**Table 1 List of Comments to Alternative Screening Report in Alphabetical Order**

**Response to Comments from Agencies and Groups  
North Split Alternatives Screening Report**

Figure 3.1 The North Split Interchange Alternative 4.c

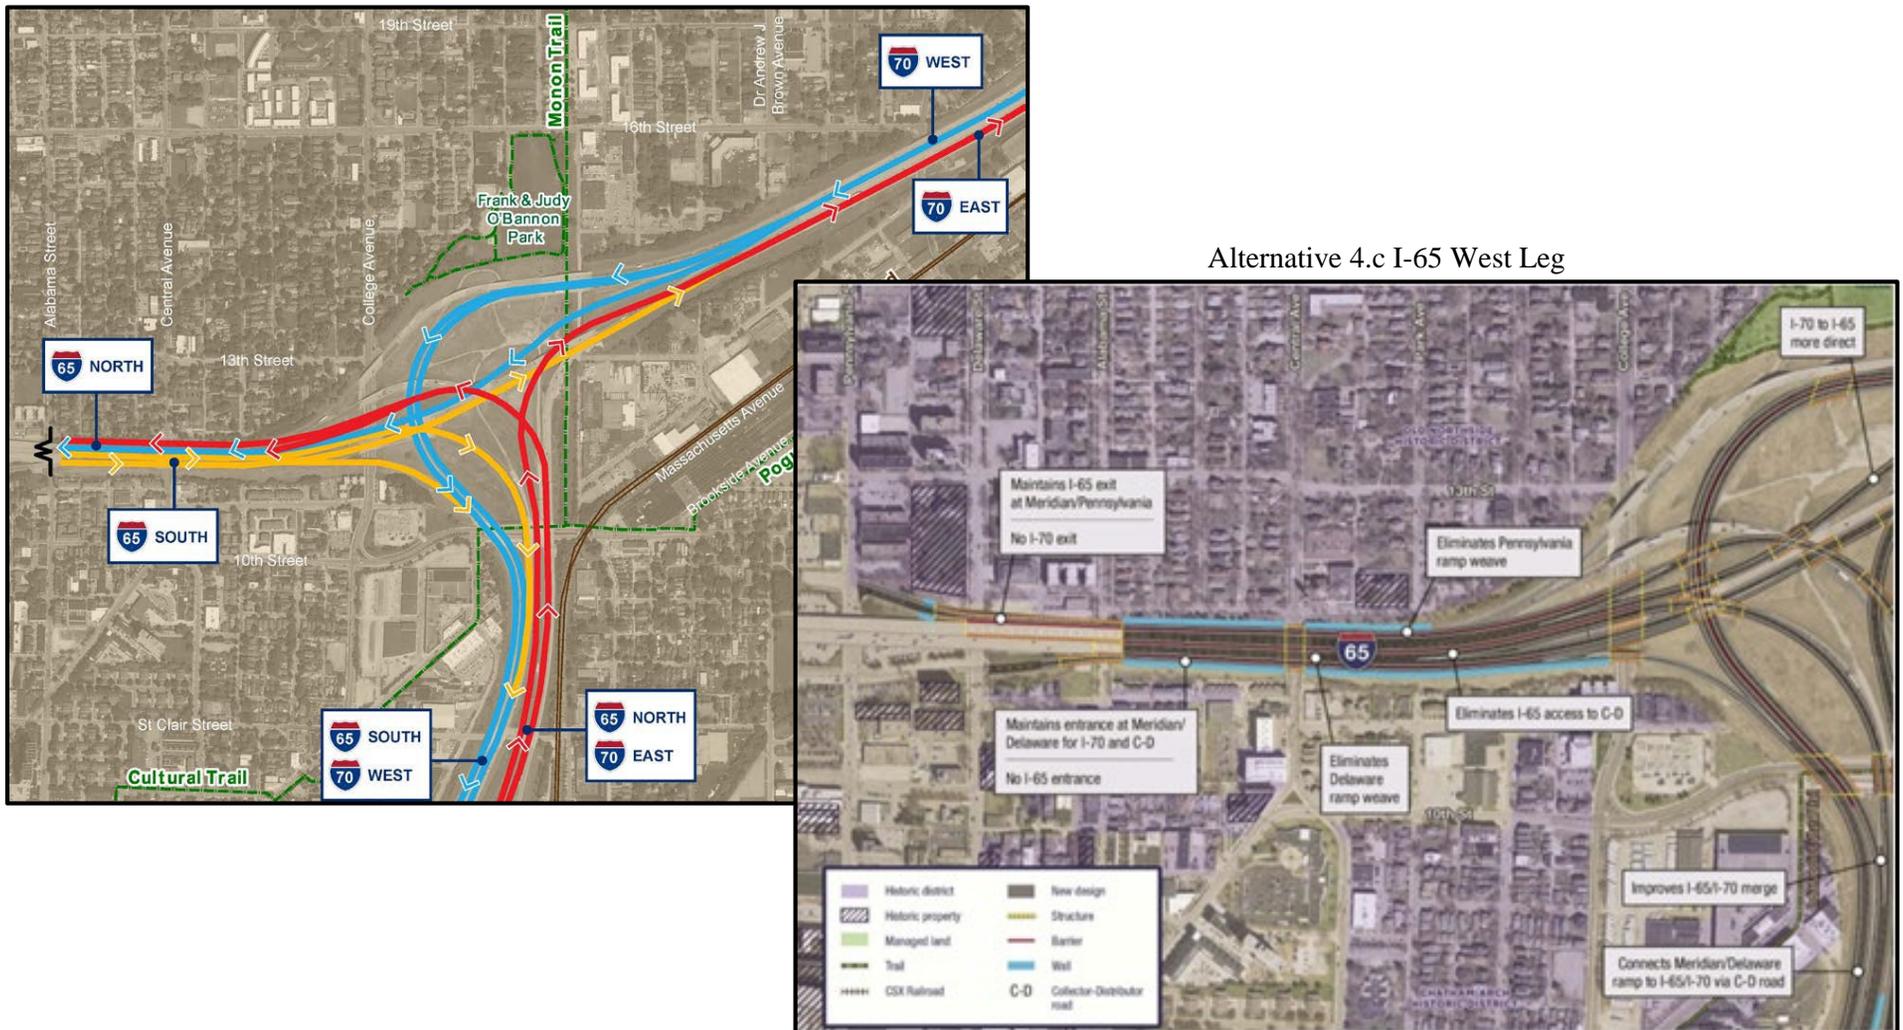
### 3. Comments to INDOT's Preferred Alternative Concept 4.c for North Split Interchange

## Proposed I-65 Cross Section at Central – Looking East

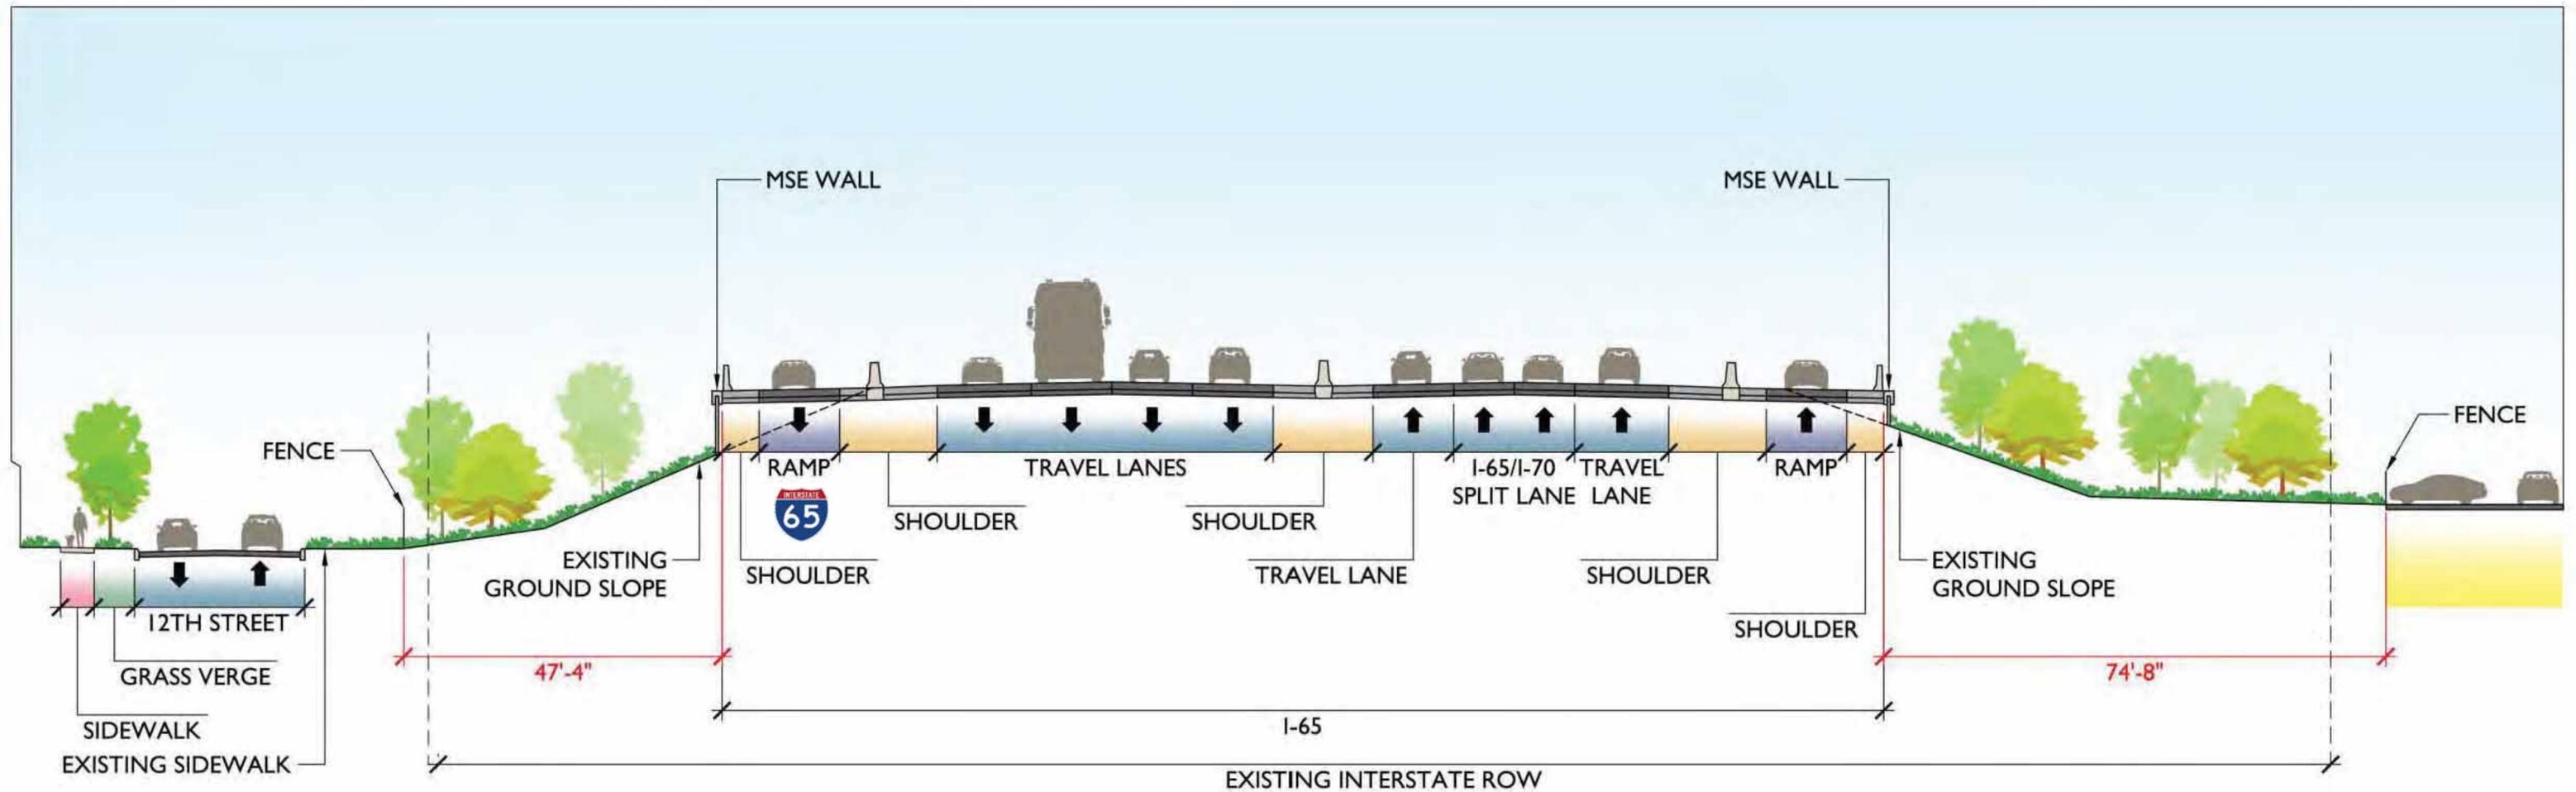
### 1. No Above Grade Walls?

*Up to 11 ft. High north (Ala. To Park) and 7 ft. high south (Ala. to College)*

## Proposed I-65 Cross Section at Central – Looking East

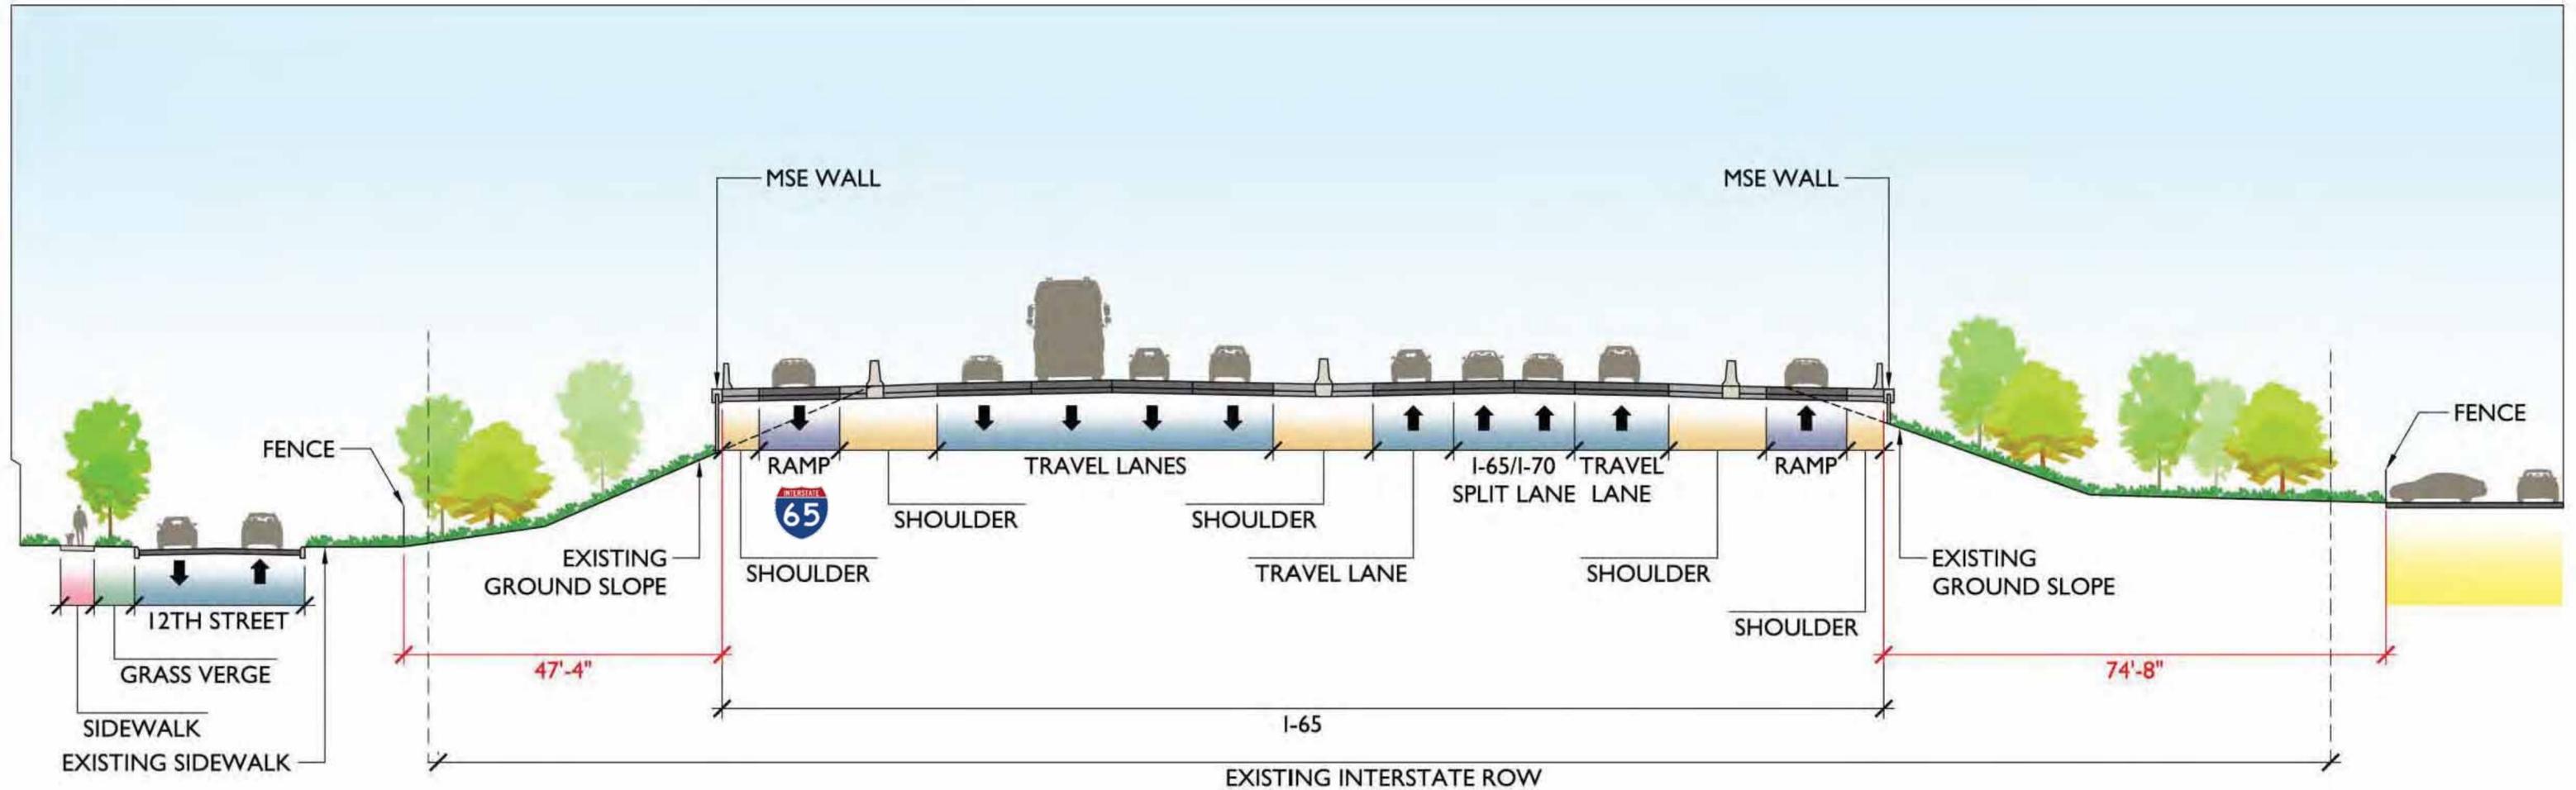
### 2. No Lane Expansion?

*Up to 22 ft. wide north and 16 ft. wide south*

## Ramp Restrictions

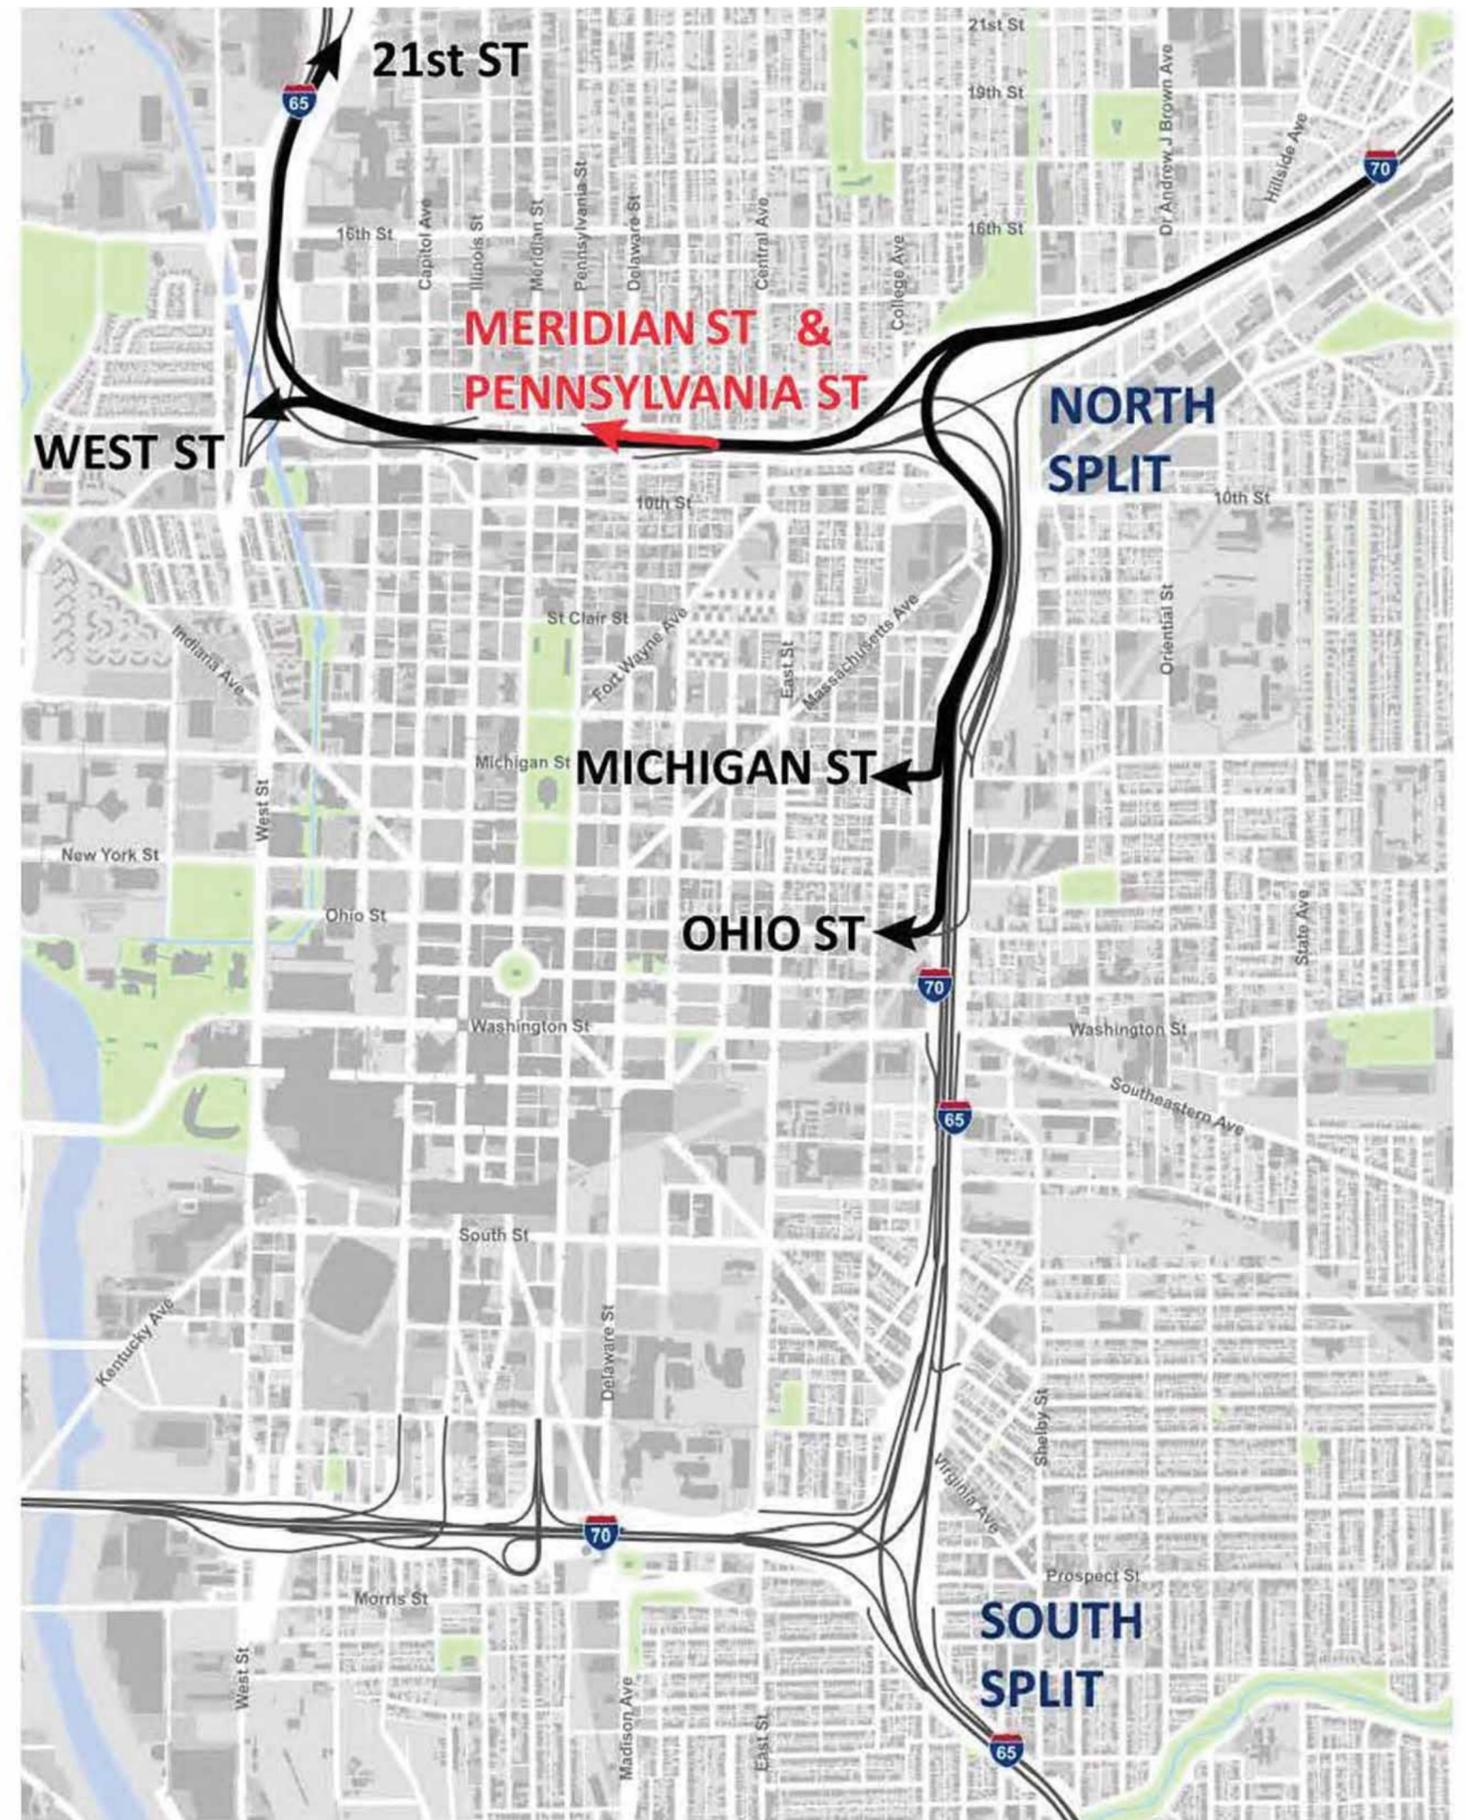
### 3. Increased Connectivity?

- *Elimination of WB 70 Exit at Meridian/Penn. drives more congestion to West Street interchange*
- *Addition congestion decreases connectivity/quality of life/mobility in NW neighborhoods*
